Subject: RE: 5100 Broadway, Oakland - On-Site Utility Trench Soil for Backfilling (RO3172)

Subject: 5100 Broadway, Oakland - On-Site Utility Trench Soil for Backfilling (RO3172)

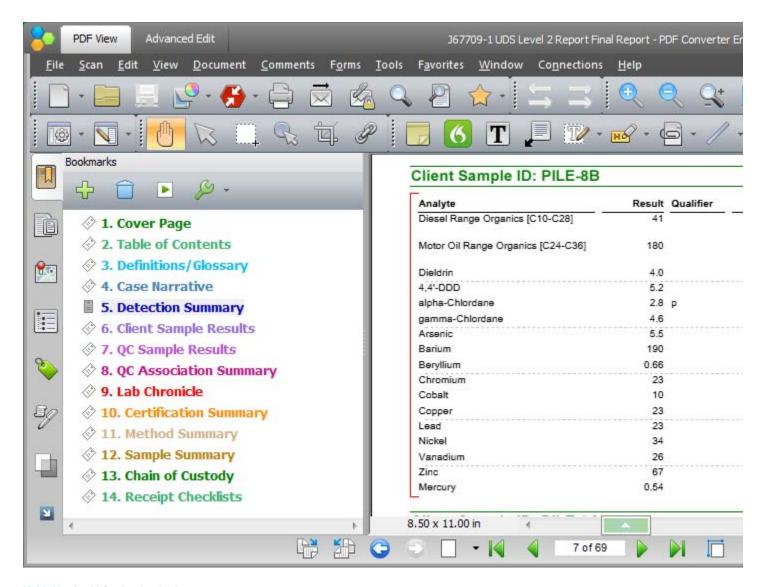
Swinerton Builders is in charge of the backfill after we complete our dig, as they need to meet their specific compaction requirements for the new Building K construction. We have some soil generated on-site - excess soil from a utility trench that was recently completed during construction – that we've tested (PILE-8B). The utility trench was located along the southeast overall site boundary, by the current pond (distant from the onsite buildings).

The <u>positive detections</u> are shown in the imbedded table below. All good, except Dieldrin (4 μ g/Kg) exceeds the Commerical ESL of 2.3 μ g/kg (for GW protection), but it's well below the 130 μ g/Kg commercial Human Health ESL for Dieldrin. The shallow(< 3m) and deep (> 3m) commercial soil ESL values for Dieldrin are the same.

Since GW is not a potential drinking water source (in this rock bathtub of a site), and Dieldrin is fairly immobile in soil, we'd like to use the 250 CY soil (PILE-8B) for the majority of the backfill in the larger rectangular excavation area, which is under the future Building K pad. Swinerton will top off the excavation when they build-up the Building K pad with import AB (as has been done with the other new buildings currently underway).

Presuming your summary is correct, your logic appears reasonable from several view points. The relative mobility of Dieldrin provides a good argument for reuse. Additionally, while the groundwater is relatively unlikely to be used, it is in an area designated as potentially useable by the SF Bay Basin Plan, and ACEH needs to observe that designation. However, burial beneath a slab and building, or pavement, and imported baserock will provide significant protection from leaching to potential groundwater. You will need to support the reuse of the material in the final report with these concepts.

Please note that if Swinerton Builders is utilizing recycled baserock, please be aware that Terramar must ensure the observance of Technical Comment 1d from our October 19, 2015 directive letter (testing to ensure clean recycled fill material).
